Access Compliance Report

Public Rights-of-Way

(Curb Ramps)

| Intersection ID: 27628 | Main Street: BALLANTYNE COMMONS PY | Cross Street: ADAIR MANOR CT | Location: SW |

| ADA ID: C6BD6CA13270 | Ramp Type: Perp | Initial Pass/Fail: Fail | Overall Compliance: No |

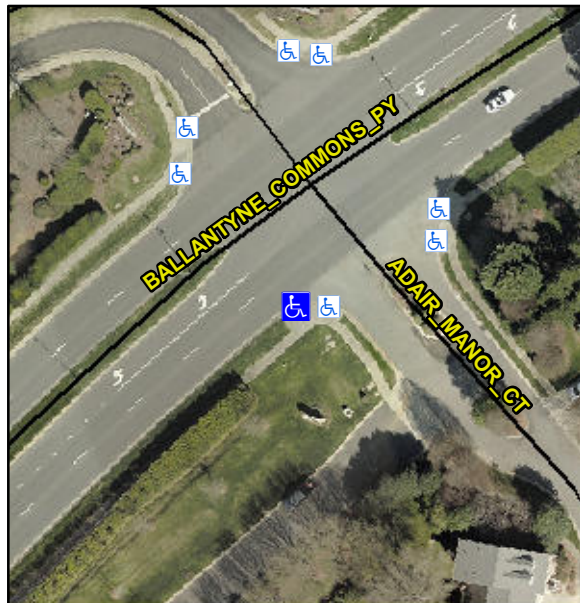
R304.5.1

| Compliance | Description | Data | Compliance | Description | Data |
|------------|-----------------------|-------|------------|-----------------------------|------|
| No | Ramp Width (in) | 34.0 | Yes | Ramp XSlope (%) | 2.0 |

Remove & Replace Entire Ramp.
